## **HOWARD & JEAN'S PLACE SUBDIVISION,** **RESUBDIVISION OF LOT 3**

APPLICATION NUMBER 5 DATE December 7, 2017  
 APPLICANT Howard & Jean's Place Subdivision, Resubdivision of Lot 3  
 REQUEST Subdivision

# DETAIL SITE PLAN

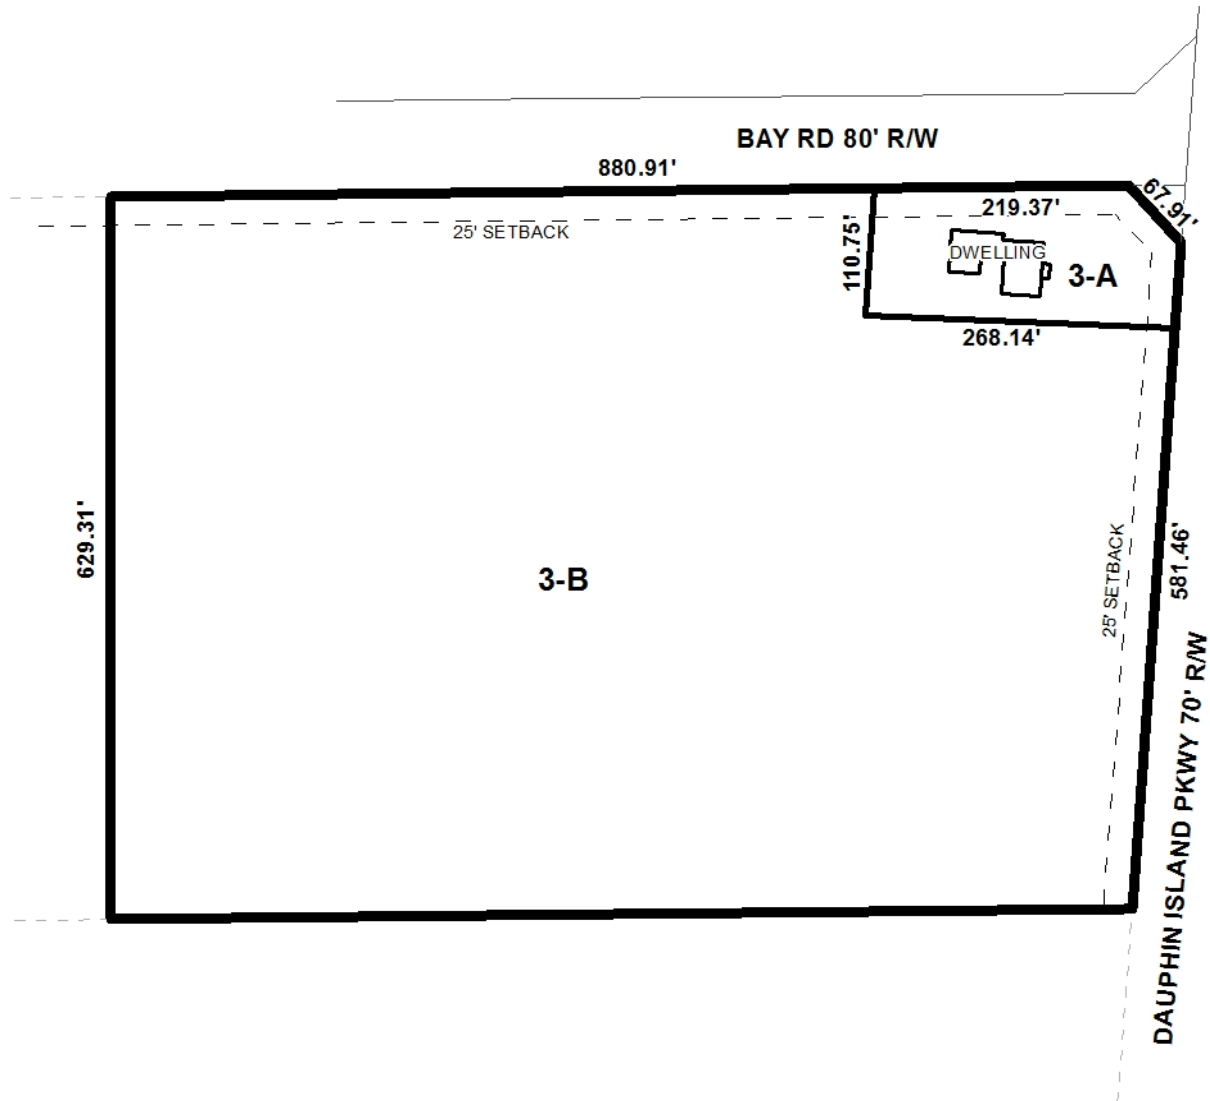
The proposed lots front Bay Road and Dauphin Island Parkway. This portion of Dauphin Island Parkway is a minor street without curb and gutter as is Bay Road, and therefore both should have a right-of-way of 60'. The preliminary plat illustrates a right-of-way of 80' for Bay Road, and 70' for Dauphin Island Parkway. No dedication is necessary to provide additional right-of-way. However, if approved, dedication at the intersection to provide a curb radii compliant with Section V.D.6. of the Subdivision Regulations should be required. If approved, the right-of-way widths should be retained on the Final Plat.

The preliminary plat illustrates building setback lines along Bay Road and Dauphin Island Parkway. If approved, the 25' minimum building setback along both frontages should be retained on the Final Plat.

In accordance with Section V.D.2. of the Subdivision Regulations, the proposed lots each exceed the 15,000 square foot minimum lot size requirement for lots served by public water and individual septic systems. The lot size information for each lot is depicted in both square feet and in acres on the preliminary plat and should be retained on the Final Plat, if approved.

As a means of access management, a note should be placed on the Final Plat, if approved, stating that Lot 3-A is limited to one curb and Lot 3-B is limited to one curb cut to Bay Road and one curb cut to Dauphin Island Parkway, with the size, design and location of the curb cut to be approved by Mobile County Engineering and conform to AASHTO standards.

- 1) Dedication to provide curb radii at the intersection of Bay Road and Dauphin Island Parkway compliant with Section V.D.6. of the Subdivision Regulations;

- 2) Retention of 25' minimum building setback line along Bay Road and Dauphin Island Parkway;
- 3) Retention of the lot size information in both square and in acres on the Final Plat, adjusted for dedication;

- 4) Placement of a note on the Final Plat stating that Lot 3-A is limited to one curb cut to Bay Road and Lot 3-B is limited to one curb cut to Bay Road and one curb cut to Dauphin Island Parkway, with the size, design and location of the curb-cut to be approved by Mobile County Engineering and conform to AASHTO standards;
